## PLANNING COMMISSION STAFF EVALUATION FIRST REVIEW

**APPLICATION NO:** 25-006A

**APPLICANT:** County Living PUD / Todd Horman

**APPLICATION TYPE:** Planned Unit Development – Concept Plan

**C-101**

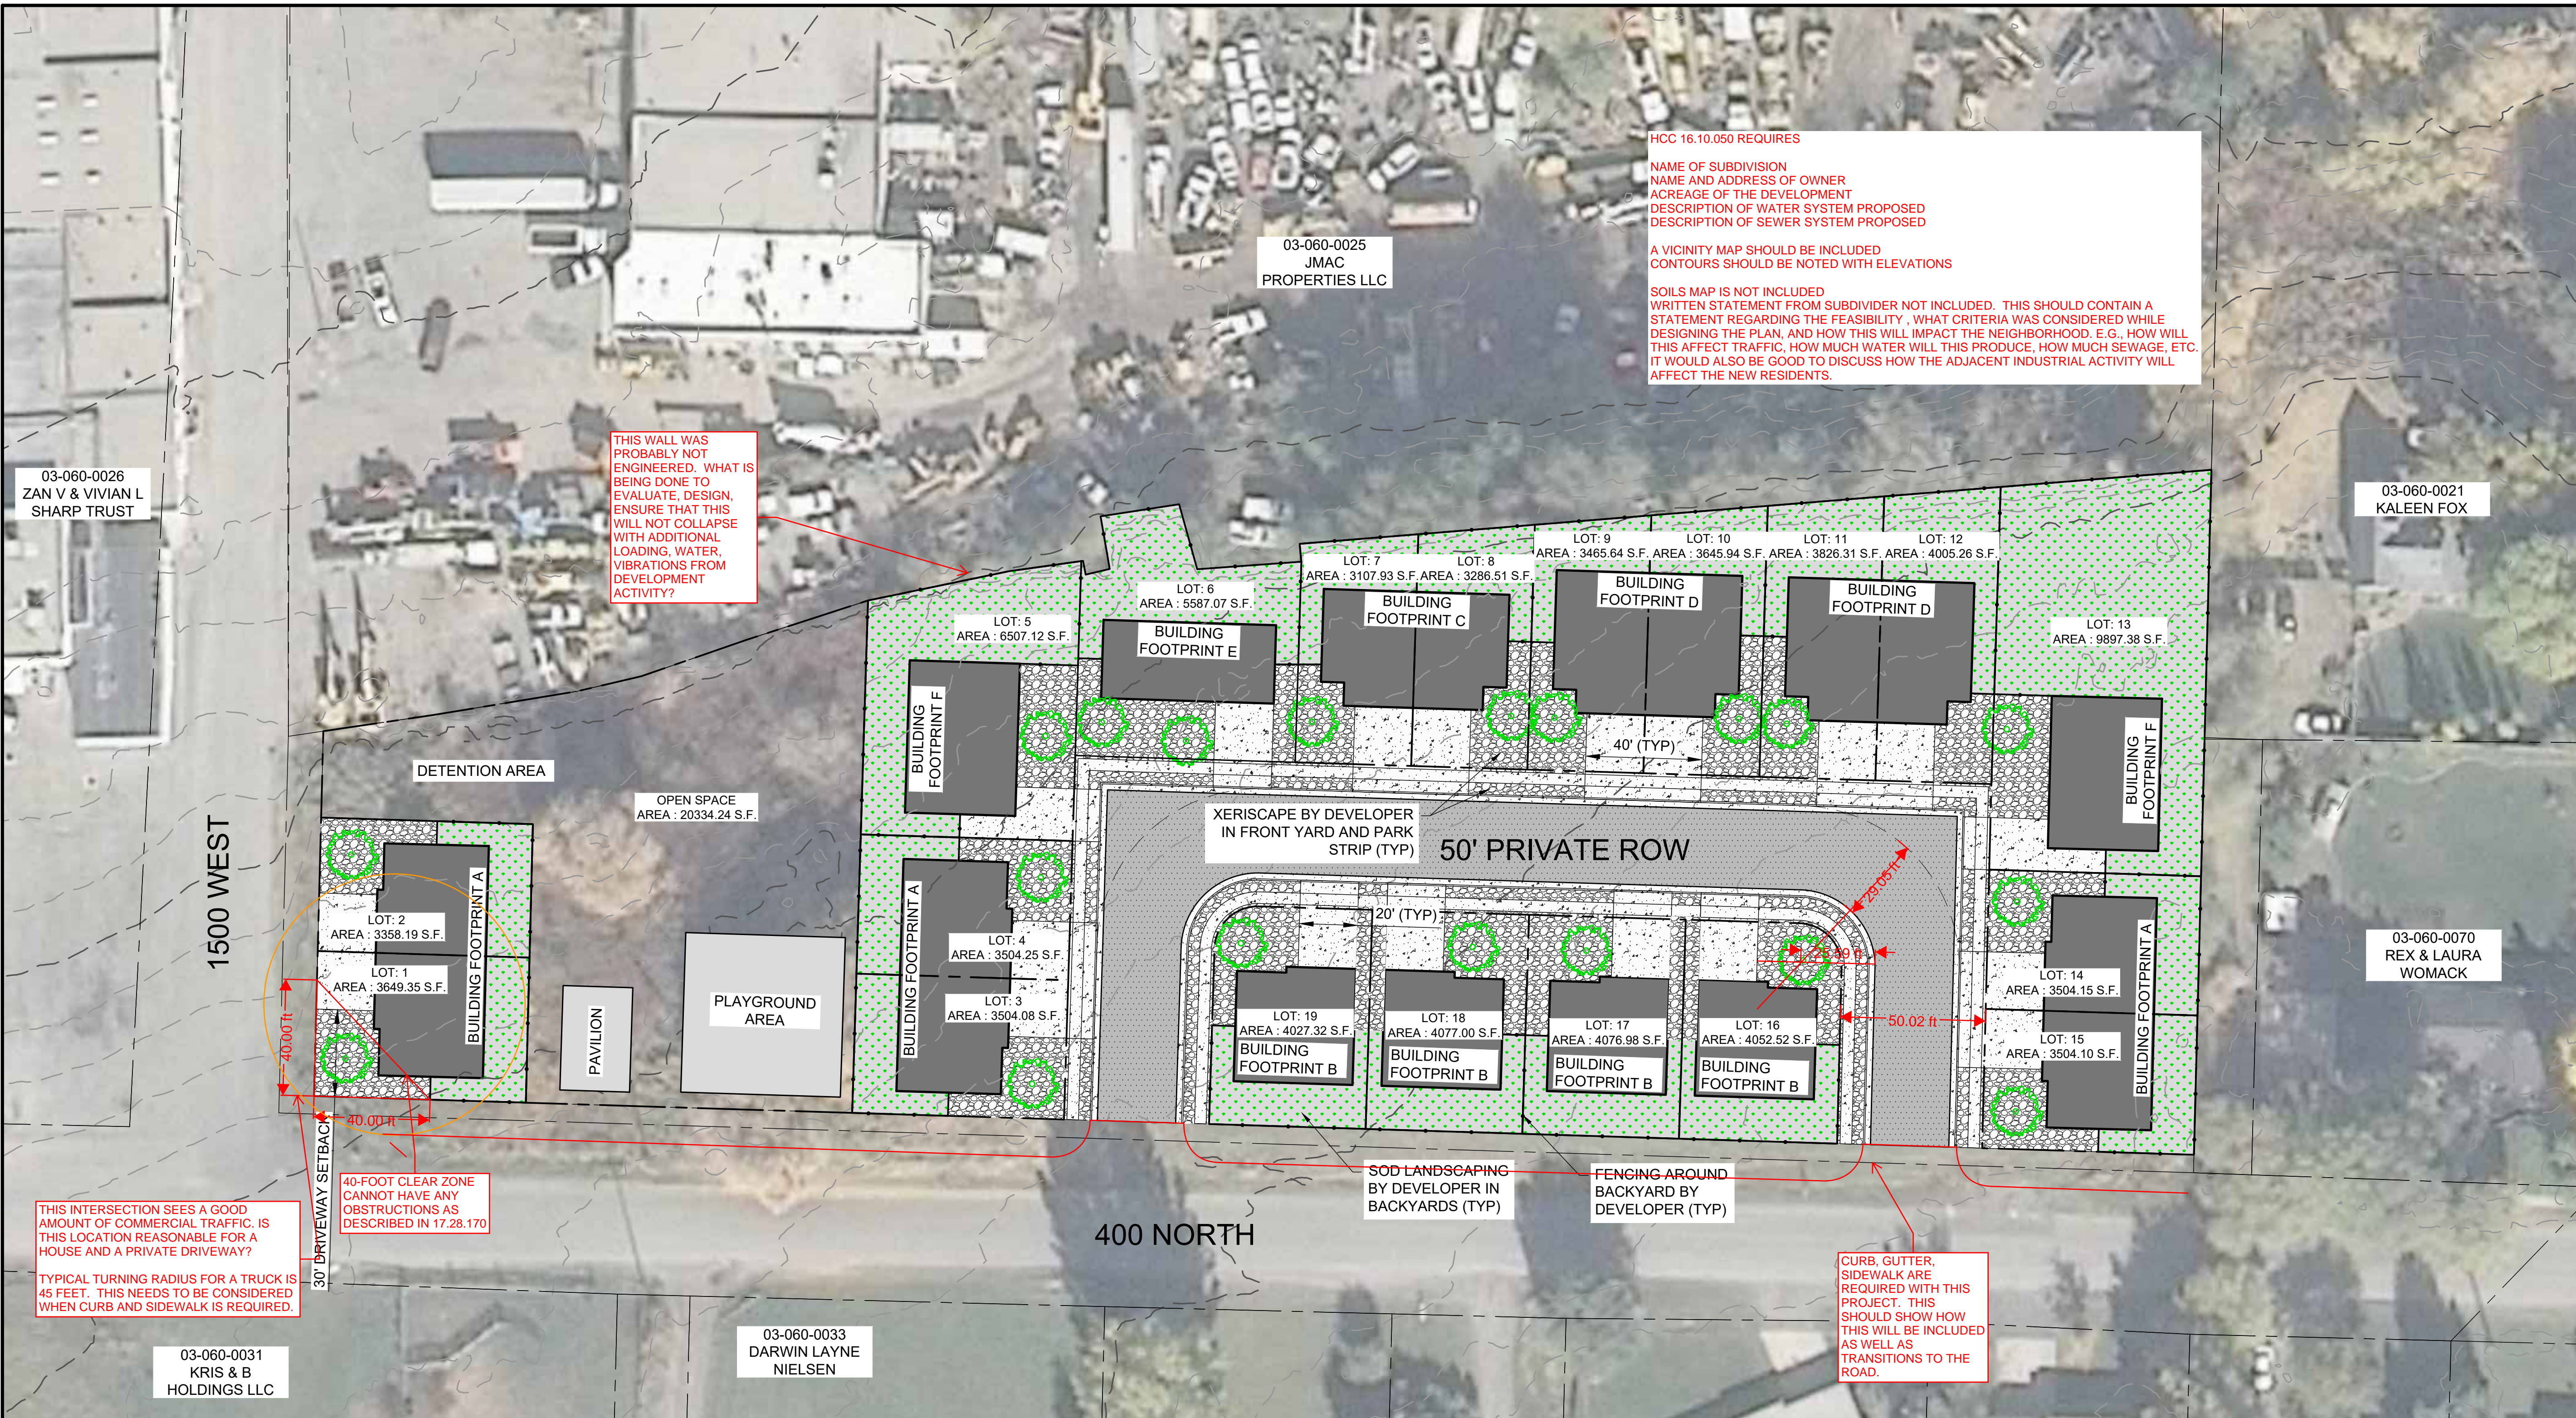
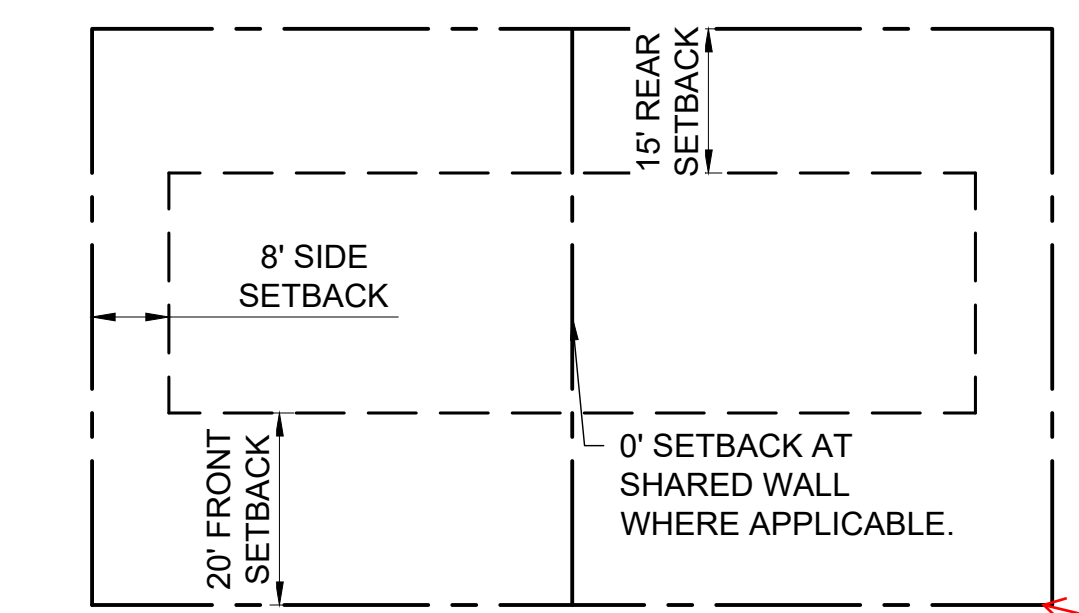
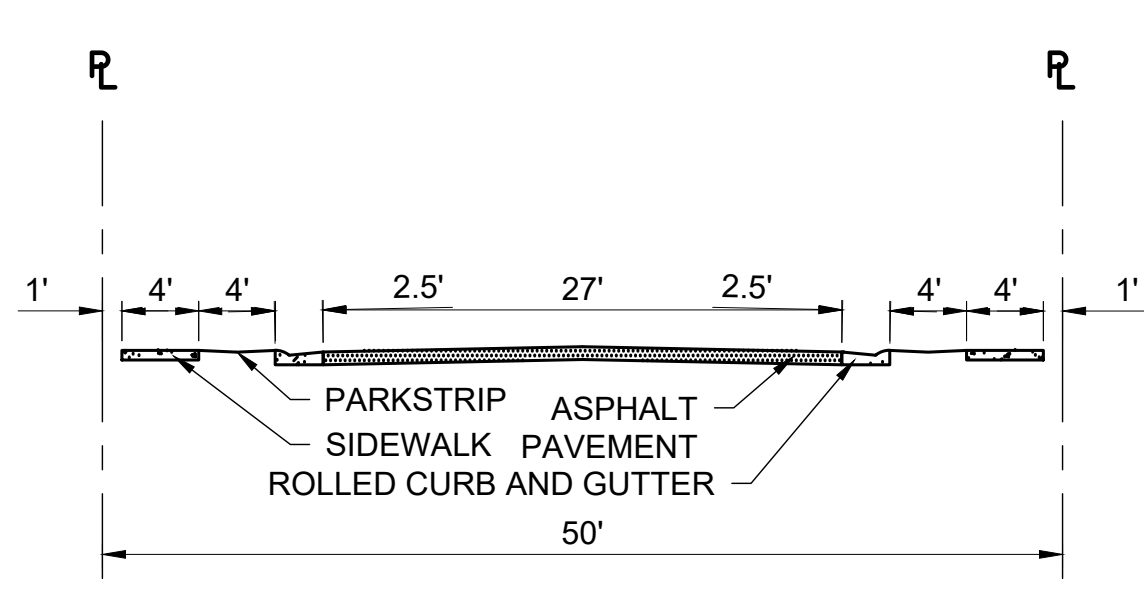
MISSING OWNER INFORMATION  
16.10.050

IS THIS THE NAME OF THE DEVELOPER OR THE DEVELOPER? IS THIS NOT COUNTRY LIVING?

CONCEPT IS REQUIRED TO BE 24X36  
SCALE: 11"X17": 1" = 60'  
22"X34": 1" = 30'

**HCC 16.10.050 REQUIRES**

NAME OF SUBDIVISION  
NAME AND ADDRESS OF OWNER  
ACREAGE OF THE DEVELOPMENT  
DESCRIPTION OF WATER SYSTEM PROPOSED  
DESCRIPTION OF SEWER SYSTEM PROPOSED

A VICINITY MAP SHOULD BE INCLUDED  
CONTOURS SHOULD BE NOTED WITH ELEVATIONS

SOILS MAP IS NOT INCLUDED  
WRITTEN STATEMENT FROM SUBDIVIDER NOT INCLUDED. THIS SHOULD CONTAIN A STATEMENT REGARDING THE FEASIBILITY, WHAT CRITERIA WAS CONSIDERED WHILE DESIGNING THE PLAN, AND HOW THIS WILL IMPACT THE NEIGHBORHOOD. E.G., HOW WILL THIS AFFECT TRAFFIC, HOW MUCH WATER WILL THIS PRODUCE, HOW MUCH SEWAGE, ETC. IT WOULD ALSO BE GOOD TO DISCUSS HOW THE ADJACENT INDUSTRIAL ACTIVITY WILL AFFECT THE NEW RESIDENTS.

THIS WALL WAS PROBABLY NOT ENGINEERED. WHAT IS BEING DONE TO EVALUATE, DESIGN, ENSURE THAT THIS WILL NOT COLLAPSE WITH ADDITIONAL LOADING, WATER, VIBRATIONS FROM DEVELOPMENT ACTIVITY?

THIS INTERSECTION SEES A GOOD AMOUNT OF COMMERCIAL TRAFFIC. IS THIS LOCATION REASONABLE FOR A HOUSE AND A PRIVATE DRIVEWAY?  
TYPICAL TURNING RADIUS FOR A TRUCK IS 45 FEET. THIS NEEDS TO BE CONSIDERED WHEN CURB AND SIDEWALK IS REQUIRED.

CURB, GUTTER, SIDEWALK ARE REQUIRED WITH THIS PROJECT. THIS SHOULD SHOW HOW THIS WILL BE INCLUDED AS WELL AS TRANSITIONS TO THE ROAD.

PART OF THE DESIGN CRITERIA TO BE PROVIDED IS:  
HOW WERE THESE SETBACKS DETERMINED?  
HOW WAS THE SIZE OF THE ROAD DETERMINED?  
HOW WERE THE OVERALL LOT SIZES DETERMINED?  
ETC.
